SUBJECT: TRANSMITTAL OF PROGRESS REPORT AND WORK PLAN AMENDMENT

19984 MEEKLAND AVENUE, HAYWARD

Subject: Amendment to the Work Plan for

19984 Meekland Avenue, Hayward, California

Plate No.: 1
Date: July 90
Scale: 1" = 20'-0"

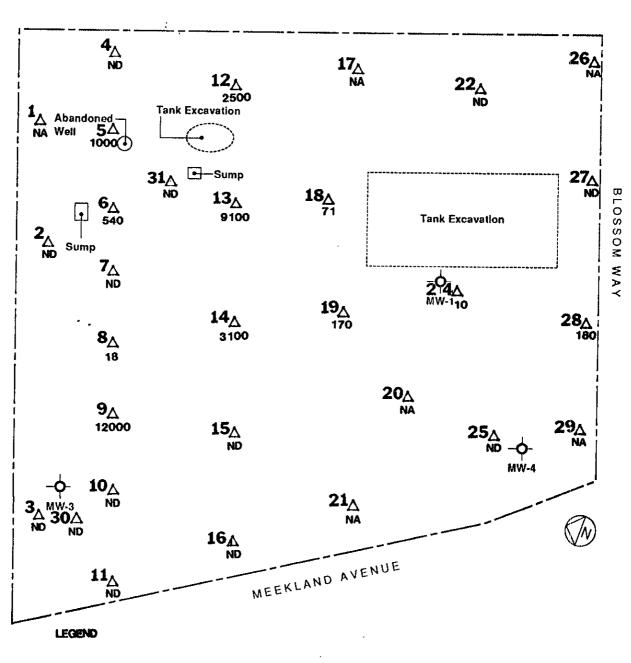
Regarding Figure 4 in your Work Plan, water regulatory guidelines specify that a monitoring well be within 10 feet of a tank removal in the down gradient direction. The figure indicates that the proposed well would be at least 15 feet from the waste oil tank excavation and not in the suspected down gradient direction. Our recommendation is that the well be placed closer to and more to the west of the waste oil tank excavation.

Page 10, Item 2 of the original work plan describes trenching activities intended to be conducted after the soil gas survey. Plate 1 of this amendment presents revised trenching locations.

Proposed trenches 1, 2 and 3 represent the locations of the three on-site automotive hoists. The purpose of these trenches is to expose the hoists and as much of the existing piping as possible. The hoists and piping will be left in place to minimize the possibility of contaminating the surrounding area with lubricating oil. At a later date, these will be removed, cleaned and disposed.

Proposed trench 4 is through the center of the waste oil line/sump that leads to the waste oil tank excavation. The line leading to the tank excavation is corroded and it is suspected that this sump/trap could be a source of contamination. Soil gas data indicates a hot spot on the south side of this sump, marked as number 13 on Plate 2. Trench 4 will be directed to this hot spot.

Proposed trench 5 is located on the northeast side of the sump located on the north side of the property (Plate 1). This is the area where the sump piping appears to be located. The purpose of this trench is to locate the sump piping and if possible, locate

Proposed trench 6 is located through the center of the waste oil tank excavation and proposed trench 7 is located on the east side/ of this pit. Data from the tank removal in 1989 indicates that the bottom of the pit is not contaminated, however, soil gas data indicates hot spots on the western and eastern sides of this ( Manage ) excavation. The purpose of these trenches is to investigate the possibility of shallow contamination. Proposed trench 4 will cover the hot spot on the west side of the pit.

Proposed trench 8 is located approximately 10' to the east of MW-Soil gas data indicated this area as being particularly high \* gasoline hydrocarbons. The purpose of the trench is to investigate the possibility of a source of contamination in this

Proposed groundwater monitoring well locations have changed since the April 6, 1990 Work Plan. Plate 1 presents the revised / locations of proposed monitoring wells 5, 6 and 7 and proposed boring B-1.

MW-5 is located approximately 15' northwest of MW-1. The reasons for this are as follows:

MW-6 is located approximately 20' from MW-3 and is located near proposed trench 8. The boring from this well will show a vertical profile of this hot spot. MW-6 will also be used for extraction, while MW-3 will be used to calculate draw down in this section of the subject site.

MW-7 is located west of the waste oil pit excavation and the sump/trap. State regulations require a monitoring well downgradient of a tank excavation. It is also important to characterize the water in this section of the subject site because the water in the abandoned well was contaminated at the time of abandonment.

B-1 is a boring located approximately 30' north of MW-4. area where the gasoline tanks from 1946 were Shallow trenching indicated that the tanks have been removed and filled with rubble. pit construction No shallow contamination was noticed, however a vertical profile would help to establish if this pit is or was a source of contamination. The boring will be to an approximate depth of 28', just above samples will be collected every 5'. groundwater. Soil BTEX and analyzed for gasoline, diesel, will be halogenated volatile hydrocarbons. After sample collection, this boring will be grouted up in a manner consistent with the regulations of Zone 7.

Plate 1 presents a revised location for a monitoring well in this area. The well is located approximately 10' from the tank excavation in the downgradient direction. However, information to date indicates the possibility of a source of contamination in this area other than the pit excavation. This source is possibly the sump/line that leads to the pit excavation. The monitoring well location is placed as to be downgradient from the sump/line as well.
